RE: **PUBLIC Comments of the Minnesota Department of Commerce, Division of Energy Resources**
Xcel Energy 2023 Integrated Distribution Plan
Docket No. E002/M-23-452

In the Matter of Xcel Energy's 2023 Integrated Distribution Plan

PUBLIC Comments of the Minnesota Department of Commerce

Docket No. E002/M-23-452

Figure 1. Xcel Capital Profile Trend 2018–2028¹⁷

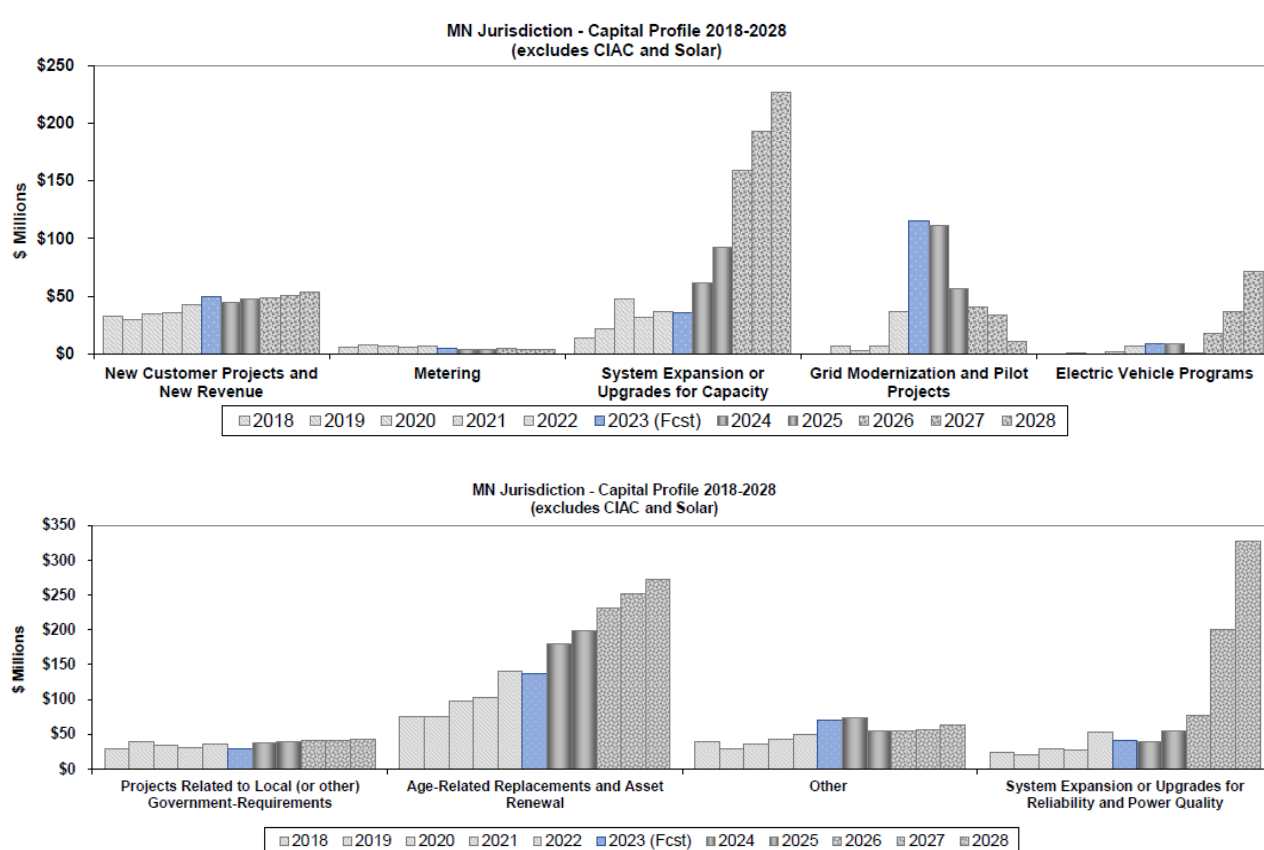
While the high-level budget summaries highlight the magnitude of total spending and increases in Xcel’s distribution system budget, the IDP includes additional detail on overall budget trends. The capital profile trend for annual costs from 2018 through 2028 provided in Attachment I, along with a brief description of cost drivers, illustrates the gradual and, at times, dramatic increases across multiple IDP Budget Categories (see Figure 1).

Xcel provides further detail for each IDP Budget Category in Attachment H, Capital Project List by IDP Category.¹⁸ Within each IDP Budget Category, Xcel provides the annual budget for three general categories of activities: blanket, program, and project. Xcel explains that “blankets fund high volume, low dollar, current year, reactive work and can contain hundreds of smaller projects.”¹⁹ The blanket costs are identified in total for each IDP Budget Category. For the general category of programs, Xcel provides brief descriptions of the unique programs included in each IDP Budget Category in Appendix D, Section B.1.²⁰ For example, in the “Age-Related Replacements and Asset Renewal” IDP Budget Category, Xcel identifies specific programs included in this category: Pole Replacement Program, Reactive Line Programs, Substation Renewal Programs, and Line Renewal Programs.²¹ Program costs in Attachment H, however, are identified in total across all the relevant programs for each IDP Budget Category, meaning that the costs associated with a specific program are not provided. Finally, the general category of projects within each IDP Budget Category identifies specific mitigation solutions

The list of capital projects in Attachment H, therefore, serves as the most detailed information in the IDP for stakeholders to understand what activities comprise Xcel's \$4.2 billion in total distribution system spending. In some IDP Budget Categories, the list identifies a significant number of specific projects and, in total, the budgets for those projects comprise a large share of the total spending in that Budget Category. Specifically, the "Age-Related Replacements and Asset Renewal" and "System Expansion or Upgrades for Capacity" Budget Categories provide the most project-specific detail. However, even for these Budget Categories, the majority of the total spending falls under the general categories of "blanket" and "program," providing limited insight into the underlying costs and the increases included in the five-year budget.

Figure 2. Cumulative Xcel Native Peak Load Growth vs Solar DER Growth for IDP Med Scenario

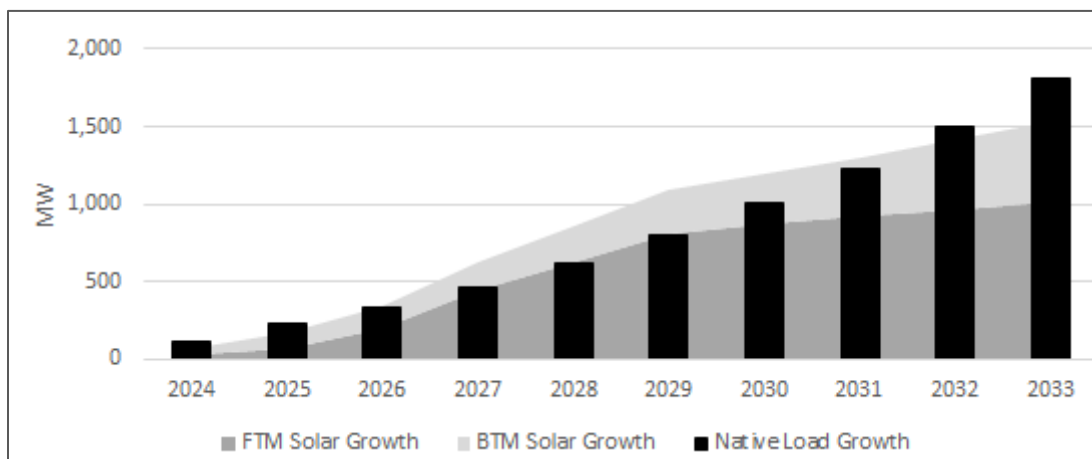
The balance between proactively planning for load growth and keeping rates low is a difficult process to navigate. This challenge is perhaps best illustrated by the push and pull of meeting the State’s goals for solar adoption. There are 261 projects on hold at capacity-constrained feeders, and 138 new projects that have applied to build solar projects on capacity-constrained feeders in the space of about

one-and-a-half years.⁴⁵ Traditionally, costs have been passed on to solar developers. Xcel discussed alternative cost allocation systems in Appendix I which could alleviate some of this stress. However, looking at the broader context of the distribution system reveals that the forecasted load growth is anticipated to surpass solar DER growth by 2032, as shown in Figure 2. In complex situations such as this, it is clear that solar developers will be subsidizing some added capacity benefits that will benefit ratepayers in the near term, raising cost allocation questions.

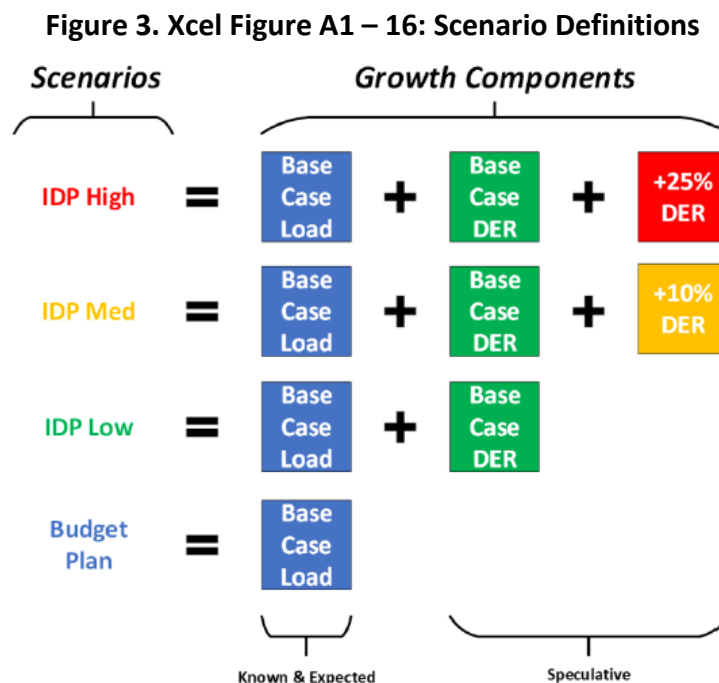
As noted above, Xcel’s budget does not generally correspond to accommodating DER adoption. As Xcel describes in its IDP, its budget plan scenario “represents the minimum desired funding level for capacity work to meet immediate distribution system capacity needs.”⁷⁷ The DER adoption scenarios then build from the budget plan with varying levels of DER adoption, namely the DER scenarios IDP

Low, IDP Med, and IDP High. Xcel provides a useful illustration to clarify this distinction across forecast scenarios, which the Department provides in Figure 1, below, for clarity:
